Southeast
Missouri State University

This letter is to clarify the issues you raised with respect to our amendment request to nuclear materials license No. 24-09296-02. Those issues are as follows:

MagIII Hall Basement Level

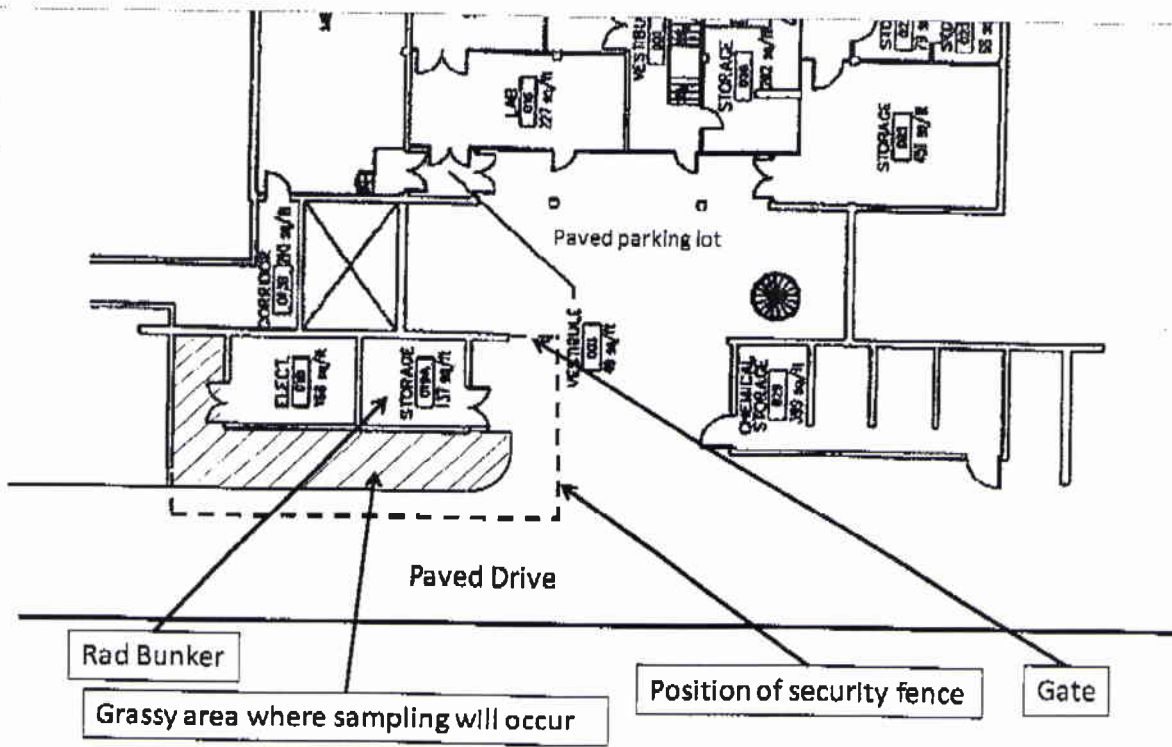
Confirm the area that will be restricted. It appears that the area of interest in your diagram is the shaded area. If so, confirm that the shaded area will be completely enclosed. Also specify the dimensions of the area.

I have included a new diagram with this letter. The shaded area in the diagram is the grassy area. The dashed line represents the outline of the fenced in area. The grassy area is approximately 8 feet wide by 42 feet long. The inset on the west side is about 10 by 10 feet. The entire enclosed area is be about 20 feet by 44 feet.
